33510B-02

Modification Recommended Service Note

33510B Function Generator

Serial Numbers: MY000000000 to MY57200600 and SG000000000 to SG57200600

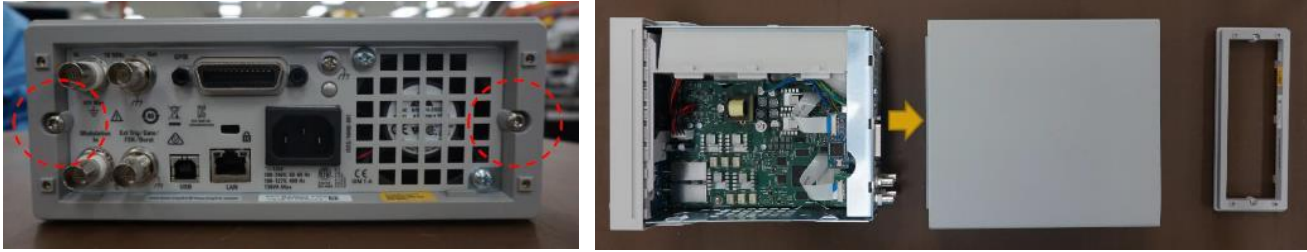
The Problem – Some customers have reported that, when line power is applied to the instrument but the instrument is NOT turned on (“Standby Mode”), some instruments will emit an audible high-pitched whistle or whine. To fix this, the existing power supply must be replaced with a newly designed power supply, as detailed in the solution below.

The solution is to replace the old power supply with a new one. The old power supply was manufactured by XP Power. The new power supply is manufactured by MeanWell, and has Part Number 0950-6082.

Old Noisy XP Power Supply (PN xxxx-xxxx)

New MeanWell Power Supply (PN 0950-6082)
